Project	<b>IEEE 802.16 Broadband Wireless Access Working Group</b> < <a href="http://ieee802.org/16">http://ieee802.org/16</a> >	
Title	Corrections	
Date Submitted	<b>2004-07-07</b>	
Source(s)	Panyuh Joo, Seungjoo Maeng, Jaeho Jeon, Soonyoung Yoon, Jeong-Heon Kim, Jaehyok Lee, Myungkwang Byun, Inseok Hwang, Jaehee Cho, Jiho Jang, Sanghoon Sung, Hoon Huh Samsung Electronics	<a href="mailto:panyuh@samsung.com">panyuh@samsung.com</a>
	Yigal Leiba, Zion Hadad, Yossi Segal, Itzik Kitroser, RunCom Technologies	<a href="mailto:yigall@runcom.co.il">yigall@runcom.co.il</a>
	Choongil Yeh, Hyuongsoo Lim, Yuro Lee, Jongee Oh, DongSeung Kwon, ETRI	<a href="mailto:lim@etri.re.kr">lim@etri.re.kr</a>
Re:	Re-circulation comments	
Abstract	Corrections	
Purpose	Adoption of the editorial in P802.16-REVd/D5-2004	
Notice	This document has been prepared to assist IEEE 802.16. It is offered as a basis for discussion and is not binding on the contributing individual(s) or organization(s). The material in this document is subject to change in form and content after further study. The contributor(s) reserve(s) the right to add, amend or withdraw material contained herein.

**Figure 261—Initialization construction for the PRBS of the randomizer**

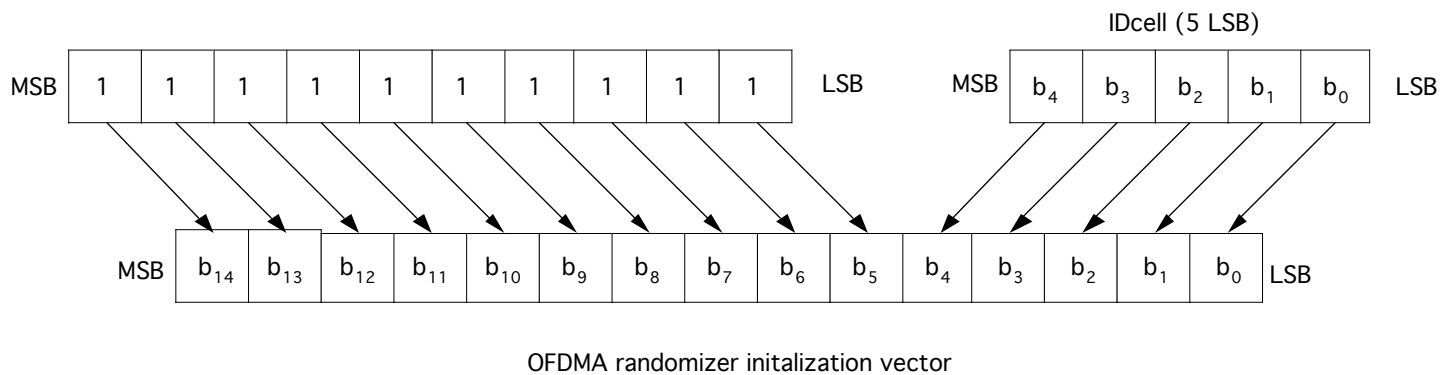
[Replace the figure 261, on pp. 607 in 8.4.9.2.3.5.2 with the following one]
